Form 3160-5
(June 2015)UNITED STATES
DEPARTMENT OF THE INTERIOR
BUREAU OF LAND MANAGEMENTFORM APPROVED
OMB No. 1004-0137
Expires: January 31, 2018**SUNDRY NOTICES AND REPORTS ON WELLS**
**Do not use this form for proposals to drill or to re-enter an
abandoned well. Use Form 3160-3 (APD) for such proposals.**5. Lease Serial No. **NMNM-024136A**

8. Well Name and No. **Cato San Andres Unit 162**9. API Well No. **30-005-20180**10. Field and Pool or Exploratory Area
San Andres4. Location of Well (Footage, Sec., T., R., M., or Survey Description)
1980' FSL 0660' FEL Sec. 28 T08S R30E11. Country or Parish, State
Chaves

**Cato San Andres Unit 162
30-005-20180
BLM
June 2, 2023
Conditions of Approval**

State of NM Orphan Well			CURRENT
Author:	Abby @ JMR		
Well Name	Cato SA Unit	Well No.	#162
Field/Pool	Cato; San Andres	API #:	30-005-20180
County	Chaves	Location:	Sec 28, T8S, R30E
State	NM		1980 FSL & 660 FEL
Spud Date	12/4/1967	GL:	4158.6'

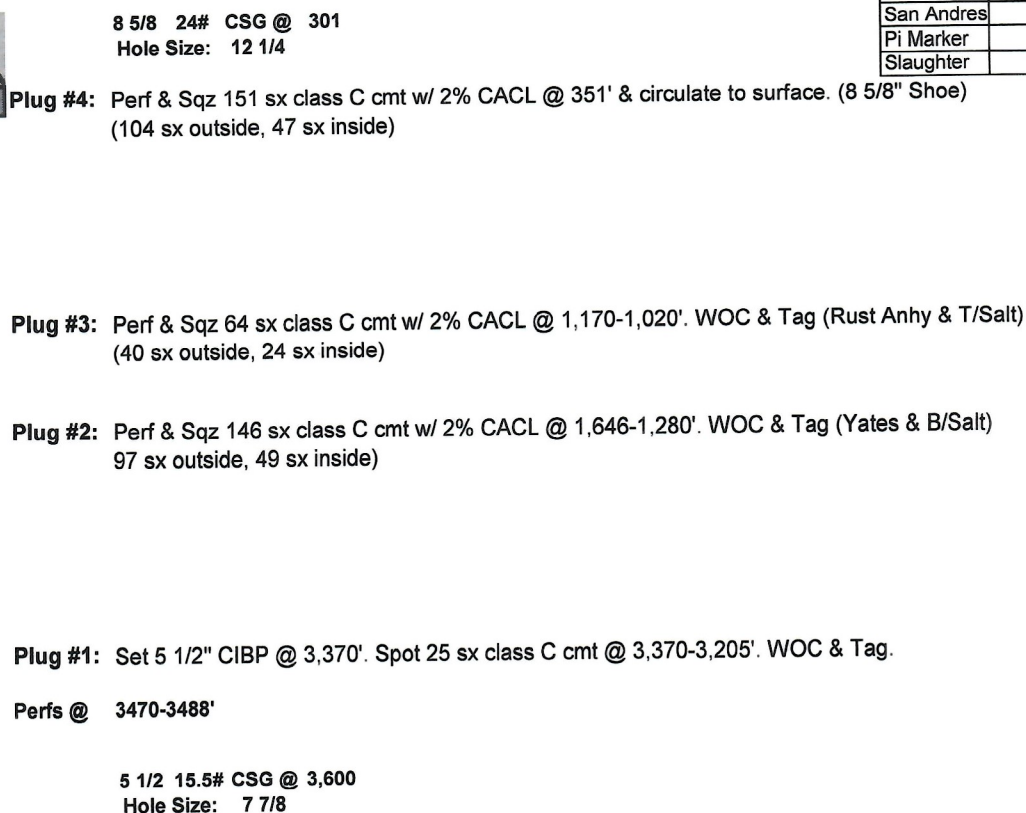
- 1. Operator shall place CIBP at 3,370' (50'-100' above top most perf) and place a minimum of 25 sx of Class C cement on top. WOC and TAG.**
- 2. Operator shall perf at 1,646' and squeeze Class C cement to 1,280' seal the Yates and bottom of the Salt Formation. WOC and TAG.**
- 3. Operator shall perf at 1,170' and squeeze Class C cement to 1,020' seal the top of the Salt Formation. WOC and TAG.**
- 4. Operator shall perf at 351' and squeeze class c cement to surface to seal the 8-5/8" casing shoe.**
- 5. Dry hole marker must be below ground.**
- 6. Surface reclamation will need to be completed once the well bore has been plugged. Please contact rflores@blm.gov for additional information.**
- 7. See Attached for general plugging stipulations.**
